CONTRACT NO. DE-AC27-99RL14047 – U.S. DEPARTMENT OF ENERGY,
OFFICE OF RIVER PROTECTION (ORP) TANK FARM OPERATIONS DIVISION
(TOD) QUARTERLY REPORT FOR THE FIRST QUARTER OF FISCAL YEAR
2007

Tank Farms Operations Division Quarterly Report

**First Quarter Fiscal Year 2007
October through December 2006**

Photo 1: AN Farm Primary Exhaust showing a light used to heat an uninsulated record sampler return after lines were blocked due to condensate freezing.

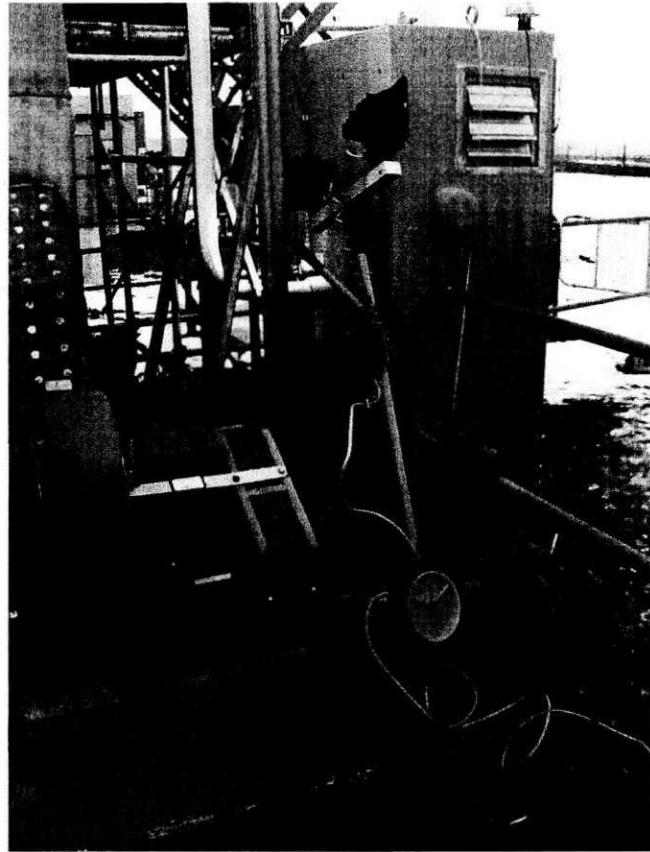
- Record sampler line freezing occurred in AW and AN Farms. In AN Farm, operations opened the drain valve on the record sampler return line and got the sampler to run. In AW Farm the return line does not have a drain and the return line was removed.
